Information note

N° 001/23

Wire sweep improvement for product TLF80511TC_GRN

Description

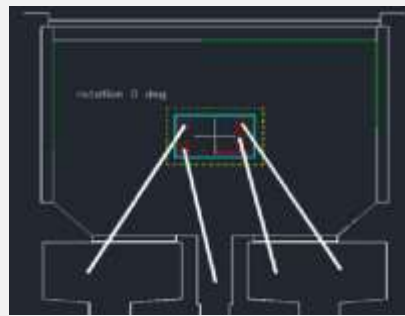
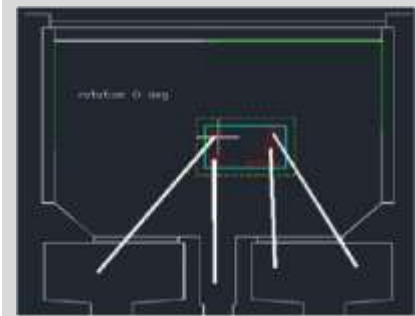
Subject Wire sweep improvement for product TLF80511TC_GRN.

Reason Improvement of wire sweep by modifying the die placement position.
